SITE AND ARCHITECTURAL REVIEW COMMITTEE
City of Campbell, California

MEMORANDUM

To: Site and Architectural Review Committee **Date:** January 22, 2020
From: Daniel Fama, Senior Planner *DF*
Via: Paul Kermoyan, Community Development Director *PK*
File No.: PLN2019-328 ~ Major Planned Development Permit Modification
Address: 100, 200, and 300 Haymarket Ct. (formally 880 and 910 Harriet Avenue)

HARRIET - PD MODIFICATION

ELEVATIONS
PLAN 2A GARAGE/ADU - LOT 4

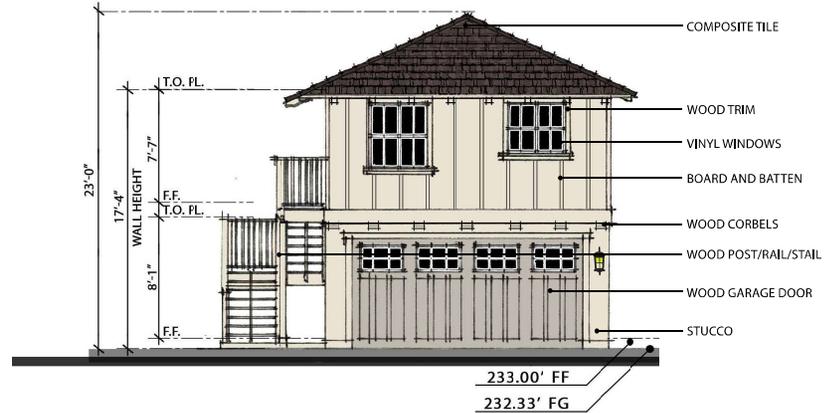
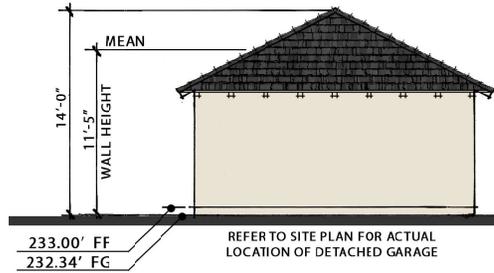
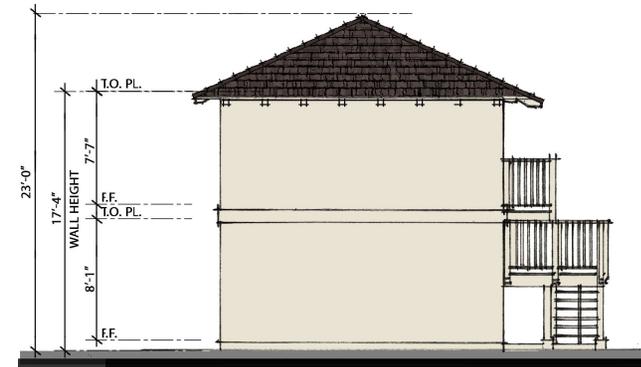
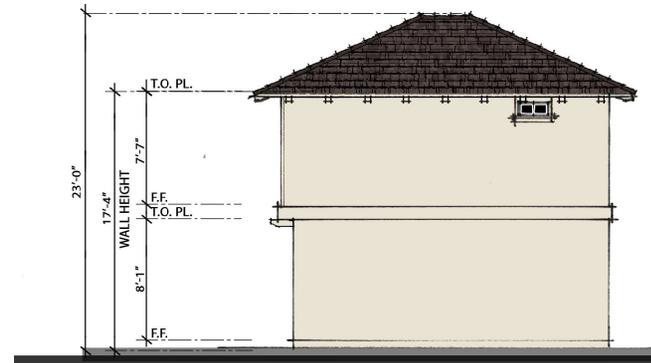
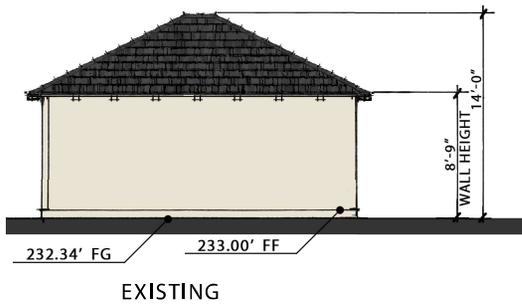
Design: The revised garage/ADU structures are shown below. The structures generally maintain design consistency with the primary homes (reference **Attachment 3** – Final Elevations), as required by the ADU Ordinance. However, staff has advised that the Lot 5 garage/ADU should incorporate shingled wall cladding to more closely match the architecture of the primary house.
